UNITED STATES PATENT AND TRADEMARK OFFICE

APPLICATION NO.	FILING DATE	FIRST NAMED INVENTOR	ATTORNEY DOCKET NO.	CONFIRMATION NO.
10/687,481	10/15/2003	Yu-Jiun Wang		8931

Office Action Summary	Application No. 10/687,481	Applicant(s) WANG ET AL.	
	Examiner Timothy M. Ayres	Art Unit 3637

DETAILED ACTION

Klakovich '768 Fig. 7

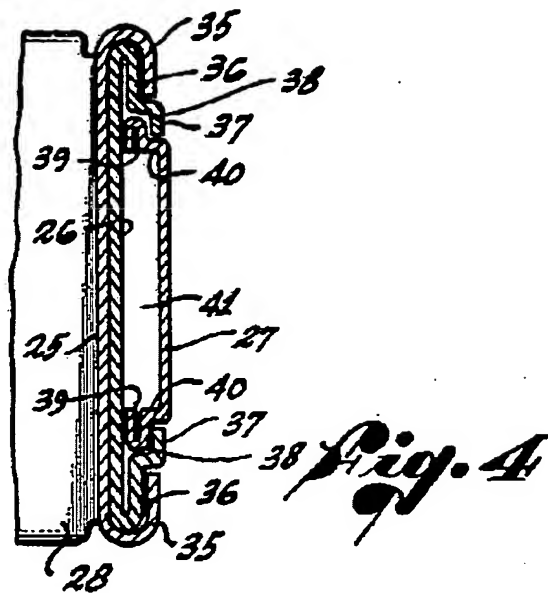
5. Claims 1-3, 5-7, 10, 11, 13, and 14 are rejected under 35 U.S.C. 103(a) as being unpatentable over U.S. Patent 3,133,768 to Klakovich in view of U.S. Patent 1,301,495 to Otte and U.S. Patent 3,059,986 to Miller. Klakovich '768 discloses a rail assembly (22) used to support electronic components. A rail bracket (25, 29) is fixed to a sidewall

of a cabinet. An outer rail (26) is movable to the rail bracket (25, 29). An inner rail (27) is movably received in the Outer rail (26). A blocking member (53) on the outer rail (26) and engages with an acting member (52) to cause concurrent movement of the inner rail (27) and the outer rail (26) (Col. 4, line 3-14; Col.3, line 51-62).

Klakovich '768 Fig. 4

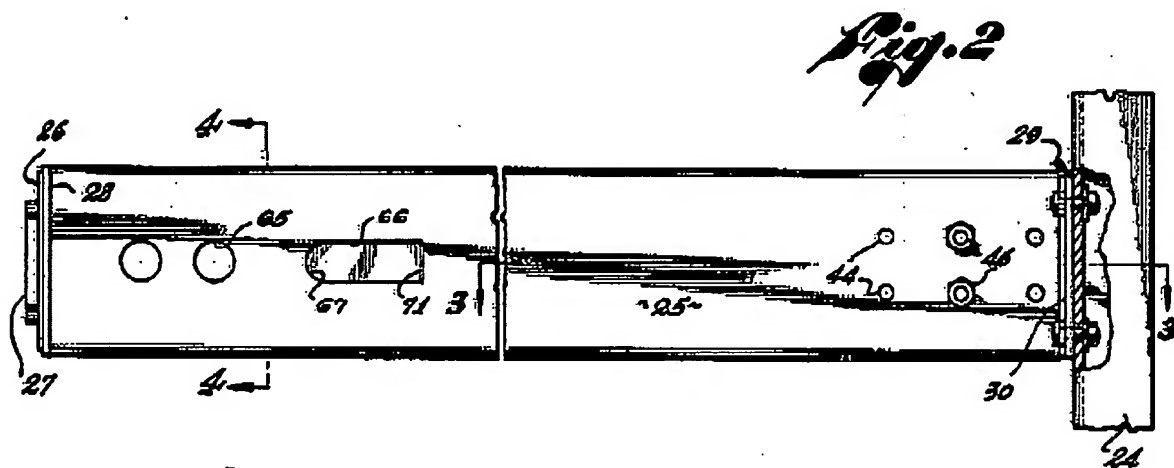
6. The inner rail (27) has flanges (39) that fit into guiding portions (38), which are created on the outer rail (26) with lip (37). Railings (36) of the outer rail (26) slide in guiding portion (35) of the rail bracket (25). The inner rail (27) and the outer rail (26) have base plates that are the straight portions defined on both sides of the gap (41).

Klakovich ('768) Fig. 2

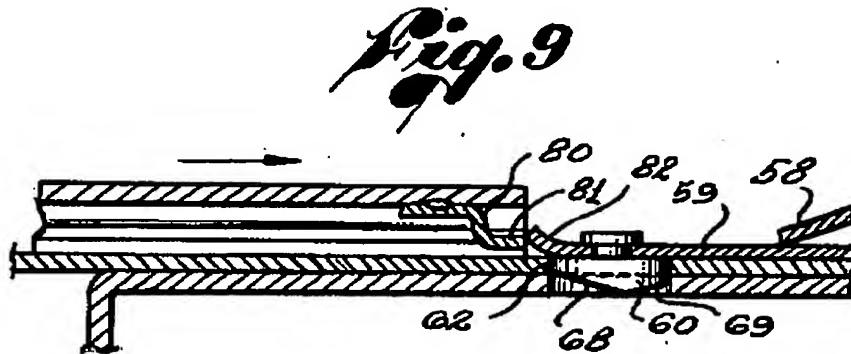
7. The rail bracket assembly includes a first part (25) that includes an adjustable bracket (29) that mounts to a cabinet. The bracket (29) is adjustably connected with multiple holes (44) and bolts (46) to the first part (25).

Klakovich ('768) Fig. 9

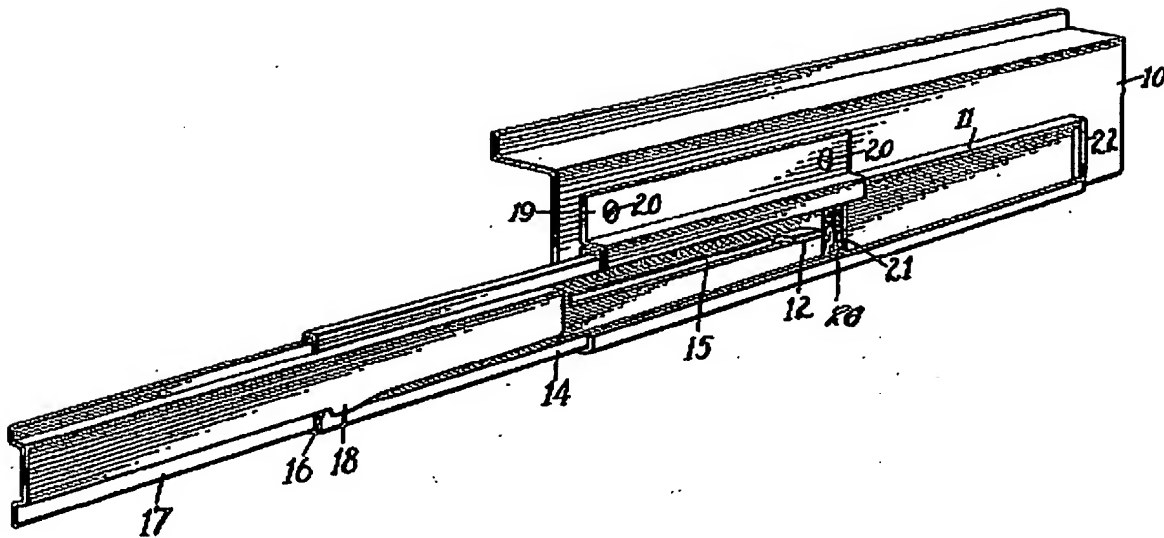
8. The rail assembly includes plate (59) attached to outer rail (26), which abuts to the tab (81) that is attached on inner rail (27) and prevent movement between the inner rail (27) and the outer rail (26).

Miller '986 Figure 14

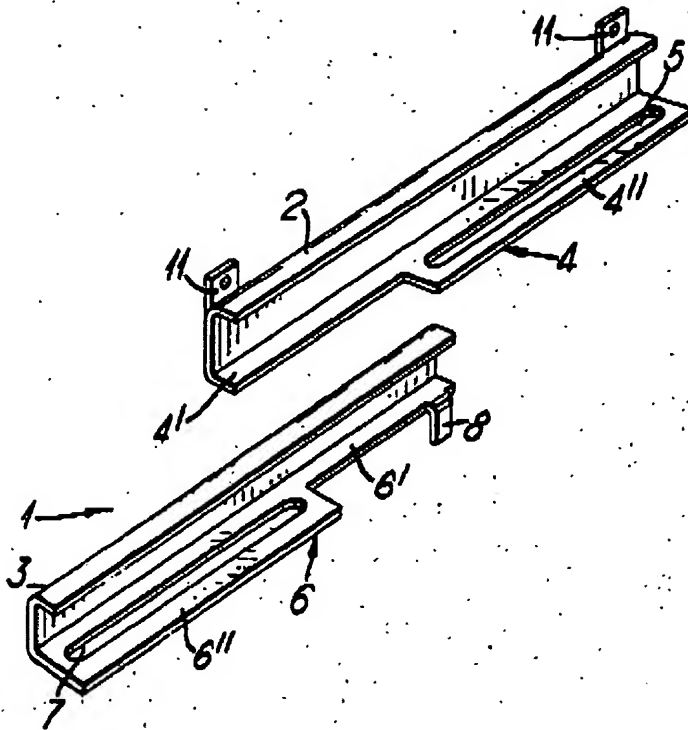
10. Neither Klakovich '768 nor Otte '495 disclose expressly that the slot communicates with a rear edge of the outer rail. Miller '986 discloses a rail assembly with a slot (28') that extends out of the rear of the inner rail (25') as seen in figure 14. The slot (28') interacts with an acting member (35') of the outer rail (20').

11. At the time of the invention it would have been obvious for a person of ordinary skill in the art to take the rail assembly of Klakovich and use the teaching of Otte to replace the acting member (52) with the protrusion (12) and to use the teaching of Otte and Miller to modify the blocking member (53) of Klakovich into a slot the extends from the rear edge of the outer rail. The motivation is to make a simple low cost rail assembly that occupies small space (Otte '495, line 13-22).

Mayer '939 Figure 9

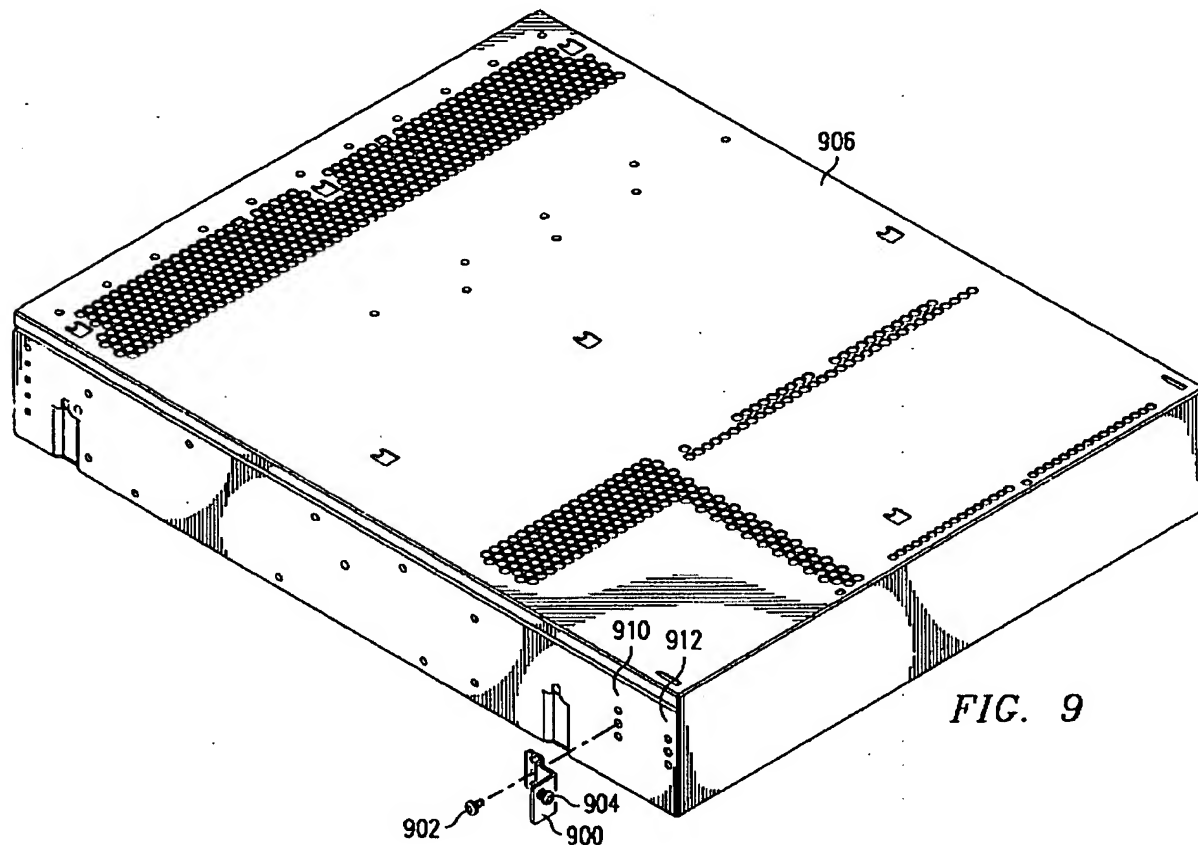
bracket (11). Otte '495 does not expressly disclose a second abutment structure attached at a front end of one of the side faces of the server. Mayer '939 discloses a second abutment structure (900) that is attached via screws (902) to positions (910,912) on the side of server (906).

At the time of the invention it would have been obvious for a person of ordinary skill in the art to use rail assembly of Otte for the server and second abutment structure of Mayer to be able to adjust the rack depth of the server (Mayer '939, col. 3m line 60-64).
